# 1978 - 1980 Corvette: Service Bulletin: Instrument Cluster Area Squeak

**Subject:** Instrument Cluster Area Squeak

**Bulletin No:** 80-T-37

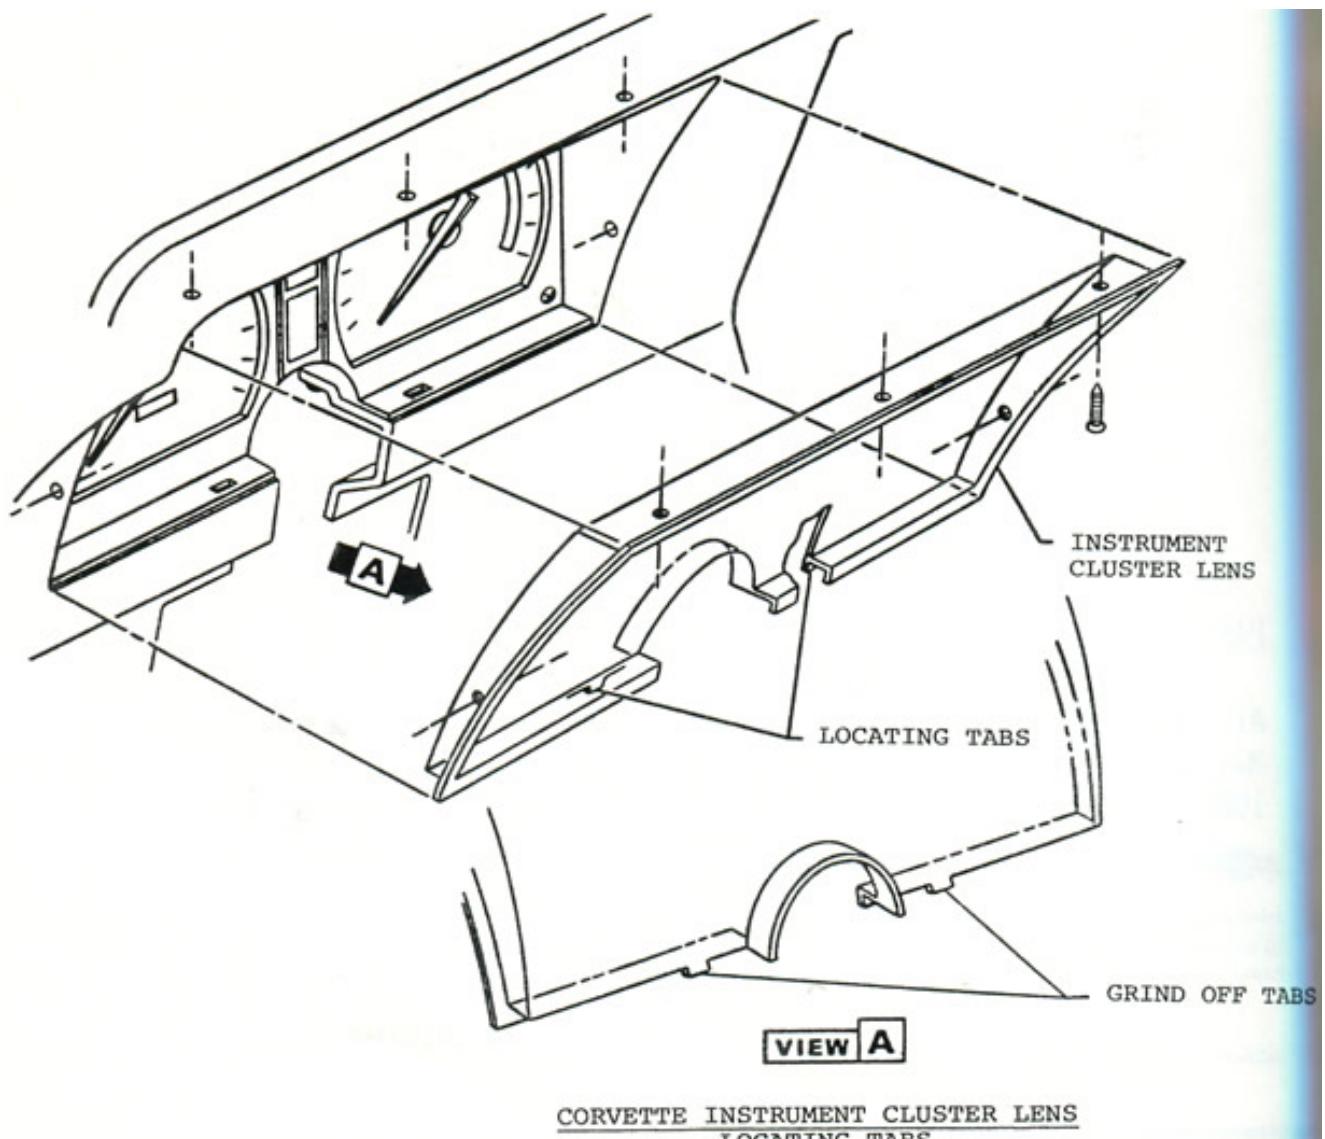
Lower tabs on cluster lens may rub against side of case locating holes. To verify this source, apply light hand pressure to lens.

Tabs will be removed from lens effective May 15, 1980.

1. Remove five (5) lens to case attaching screws and remove lens.
2. Grind off and file to a smooth surface the two (2) plastic locating tabs at bottom of lens, as illustrated on Page 2. **CAUTION** : The plastic lens is brittle and may crack if the tabs are snapped off rather than ground.
3. Reinstall lens to case with five (5) screws.
